APPROVED BY:
CK'D BY ___ OK'D BY CER
RESUBMIT ___ APPROVED As Noted
BY RSY DATE 10/18/2011

BRIDGE RAIL DETAILS SHEET

ROUTE 12A, BR 15 & BR 22
TOWN OF ROXBURY, WASHINGTON COUNTY, VT

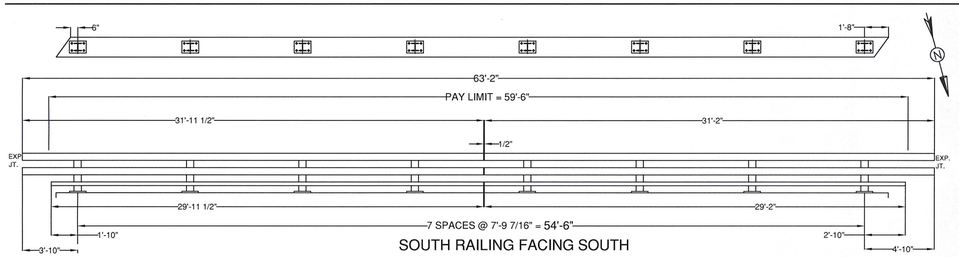
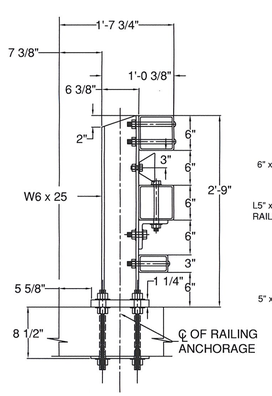
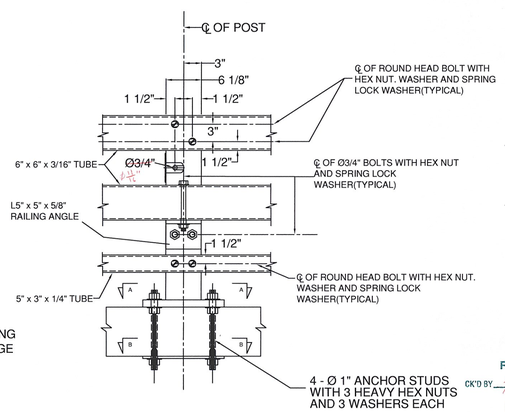
No mention of washers (plate or lock). Nut tightening should include OK.
